Agenda Supplement

January 10, 2024
HDC Meeting

Applicant Submitted Information

Hamilton Residence

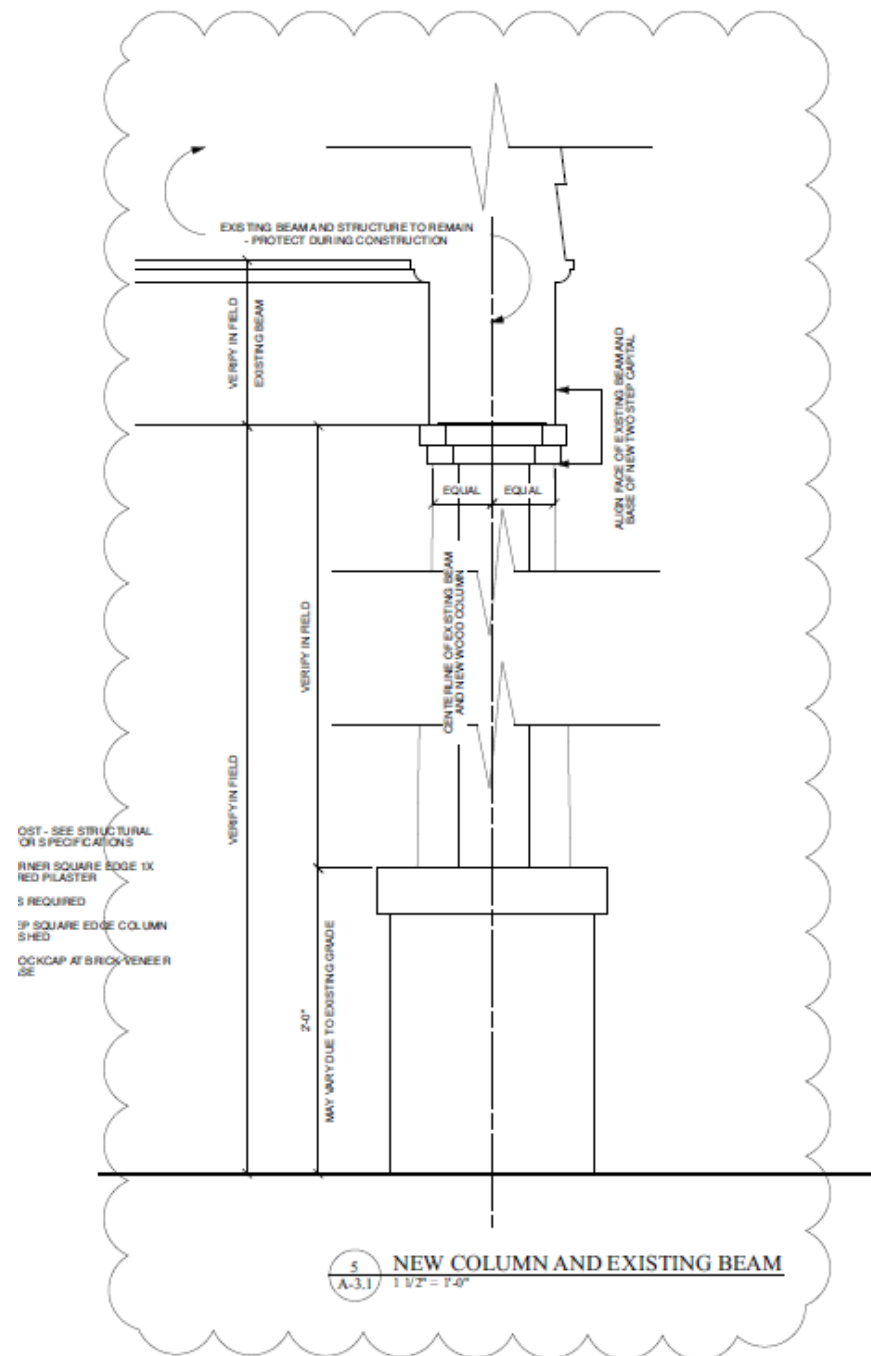
Staff Analysis/ Comment

1. Front Elevation
 - a. Loss of mullion trim – *We have the option to reduce the width of the new French casements and still meet egress requirements if the larger mullion trim is desired by the Board. We would like to keep the new windows as French casements to meet current egress requirements and the windows with the mutins in lieu of the original casement design.*

- b. Design of the replacement windows – *The existing double hung windows and fixed windows are from an earlier renovation. It is the intent of the new windows to evoke the original casements and the original craftsman style.*

- c. Roof trim – *It is the intent to emphasis the Craftsman style eave detail.*
2. Rear Elevation
 - a. Asymmetrical rear gable – *The intent is to work within and under the existing main roof ridge parallel to Hermitage Court. The new additional square footage roof should not be seen from the street and the new rear dormer should feel like it was always there. We worked with two factors in mind: align the new roof eave with the existing eave and the new roof should not extend above the main existing roof. The new roof will be non-vented and there will be no ridge vent.*

3. Left Elevation
 - a. Fenestration – *It is the intent to simplify a previous renovation and streamline the roof design.*
4. Provide Specifications and Sample of Loewen Window – *A sample of the double hung window was given to HDC. The windows shall be wood to match the existing. The exterior casing shall match the existing and shall include the sill.*

5. Beam/ Column – *The intent is to keep the existing front porch and porte cochere beam. Notes in the drawings that refer to a “new beam” shall be removed from the drawings. Please note, if the beam cladding needs to be repaired or replaced, it shall be installed to match the existing wood and reveals. See 1/ A2.0, 2/ A2.0 and 5/ A3.1.*

Please note that there is currently a second floor existing at 416 Hermitage Court. Our intent is to rework the existing space under this existing roof with new additional square footage at the rear.

Rear Yard Open Space Calculations Worksheet

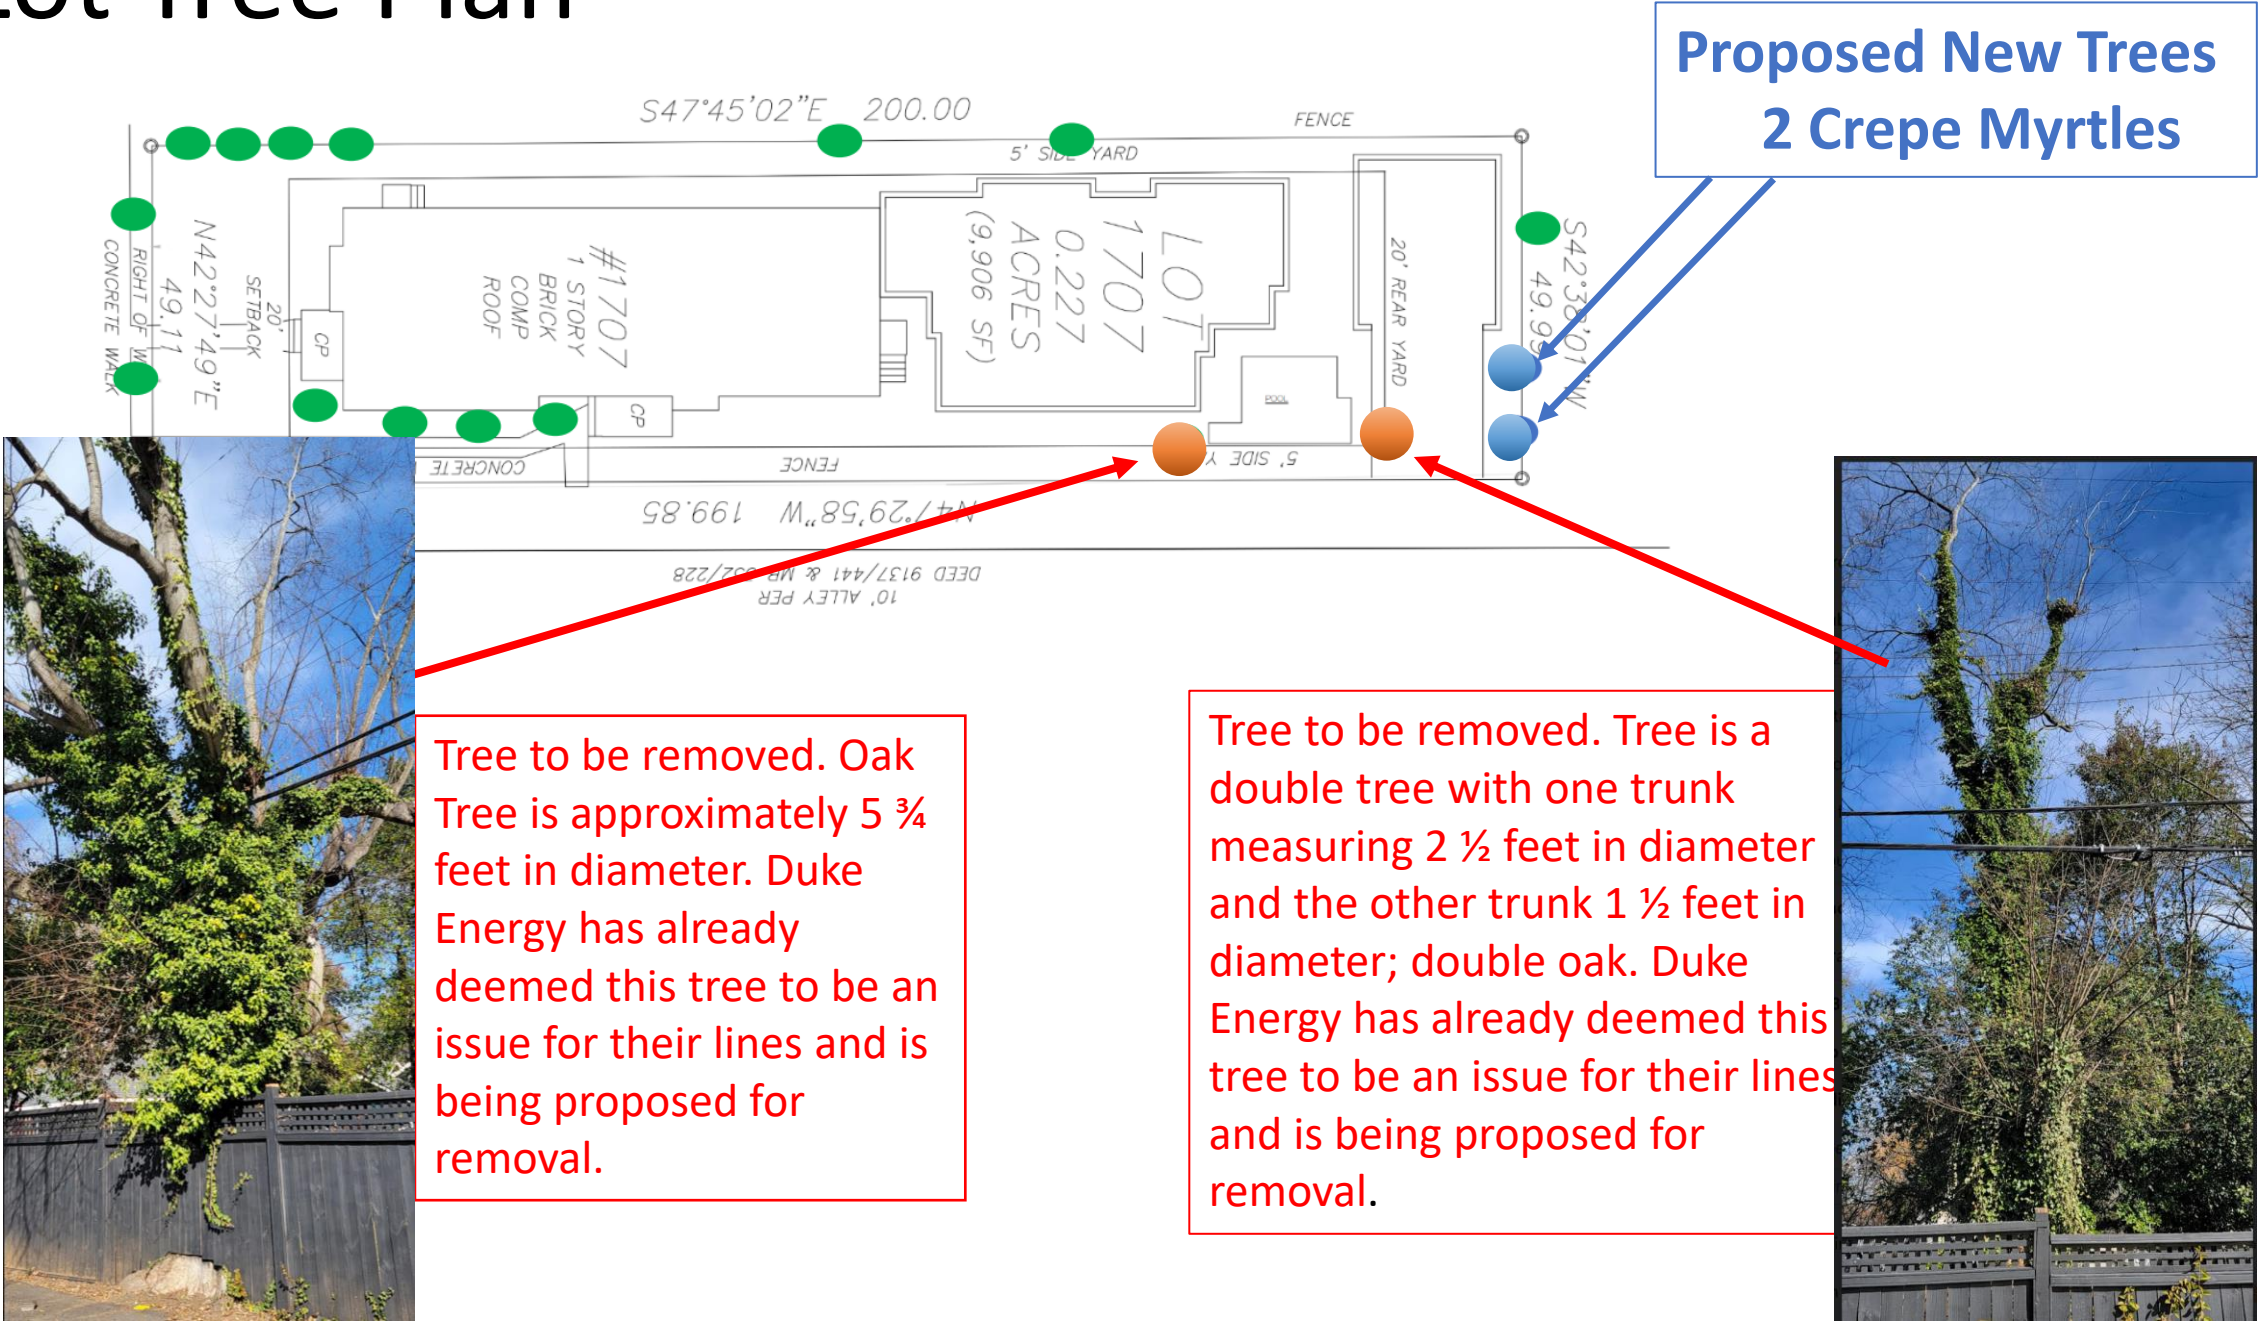
Rear Yard
Calculations shown
here are based on if
we were Residential.
We are zoned Multi-Fam and technically
these restrictions
are not applicable.
In attempting to
maintain as much
pervious as we
could, we only
exceeded by 3%.

Front Entry

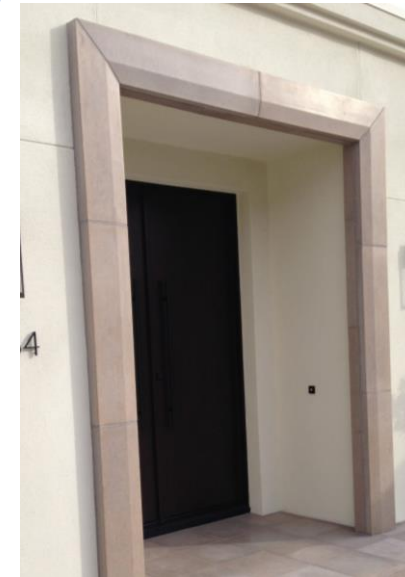
This overhang has been deleted.

The casing at front façade where the recessed entry starts, propose either a precast or wood trim surround to break up the brick and emphasize the entry. Approximately 8-10" wide all around.
